## Review of "Precise water level measurements using low-cost GNSS antenna arrays"

By David J. Purnell, Natalya Gomez, William Minarik, David Porter, and Gregory Langston

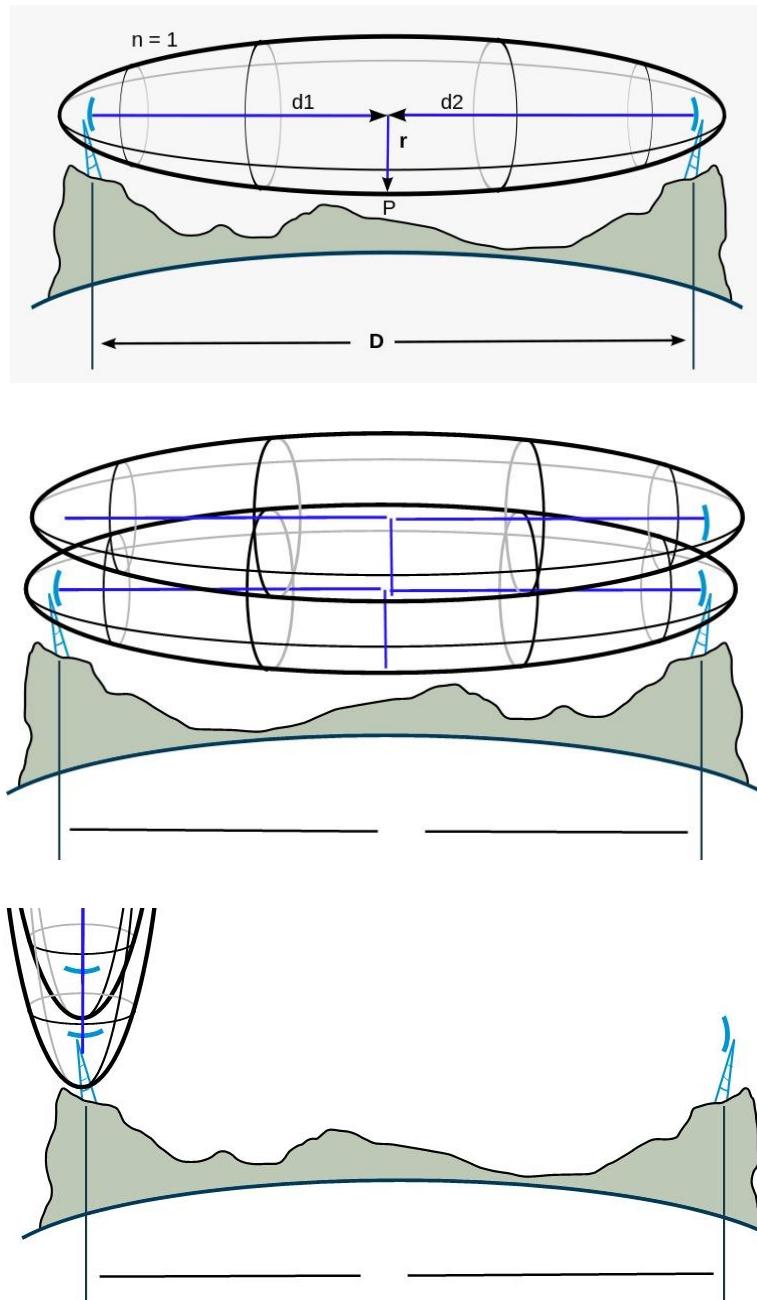
**Reviewer:** The antenna is at the ellipsoid focus, which lies inside the ellipsoid volume, and should not be confused with the ellipsoid vertex, that lies at the tip of the ellipsoid surface. Thus, the first Fresnel zone surrounds the antenna instead of being entirely in front of it. The extreme case of a satellite at zenith is clearest: for an array, the direct FFZ will be stacked, with the top antennas obstructing the bottom ones. For a satellite at the horizon, the clearance requirement near the antenna would be least. In general, for satellites at an arbitrary elevation angle, the clearance in the direction perpendicular to the line of sight would be converted to the vertical clearance, with the secant of elevation angle. So, higher elevation angles will be compromised more than lower elevations.

"We note that the distance of 25 cm may not be large enough to avoid interference between antennas."

" Whilst our results suggest that the spacing apart of antennas is not important, we cannot rule out the possibility of interference between antennas at the separation distances used in this study. A rigorous investigation of the clearance distance required to ensure that antennas are not

interfering should guide a future study."
